PRODUCT CHANGE NOTICE

1. TITLE Dimensions, UBC / UBCN Package Types		2. DOCUMENT NUMBER FV5-C-20-0003
		3. DATE October 18, 2019
4. MANUFACTURER AND ADDRESS International Rectifier HiRel Products, Inc 205 Crawford Street Leominster, MA 01453		5. MANUFACTURER PART NUMBER See below for IR Part Numbers
		6. BASE PART NA
		7. NATIONAL STOCK NUMBER (NSN) NA
8. CAGE 69210	9. EFFECTIVE DATE November 15, 2019	10. GOVERNMENT NUMBER NA
11. POINT OF CONTACT Manufacturer's Representative or Account Specialist (978) 534-5776		12. DRAWING NUMBER NA
		13. SPECIFICATION NUMBER MIL-PRF-19500/744, MIL-PRF-19500/745

Case Outline and Dimensions (UBC / UBCN Package Types)

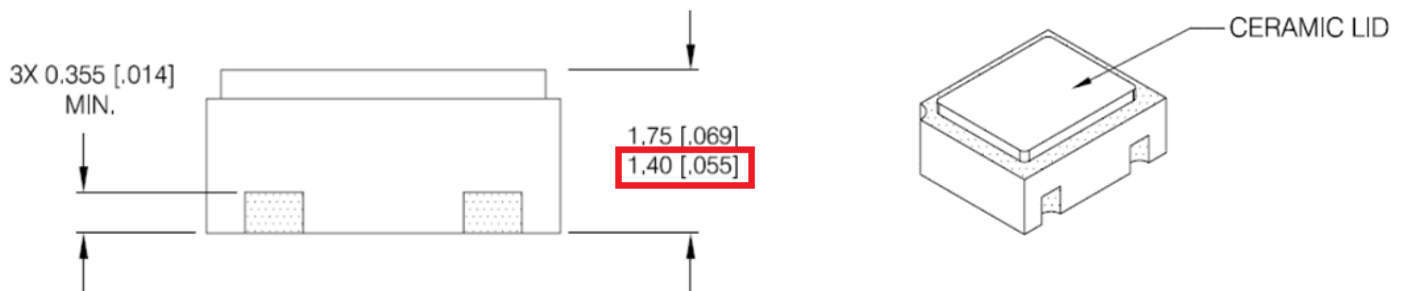
This GIDEP PCN is to announce specifications change with the datasheet mechanical dimensions for the following International Rectifier Part No. Note that this change is related to package specification only, and not due to a die physical change.

Mechanical outline, change minimum height from 1.40 [.055] to 1.27 [0.050].
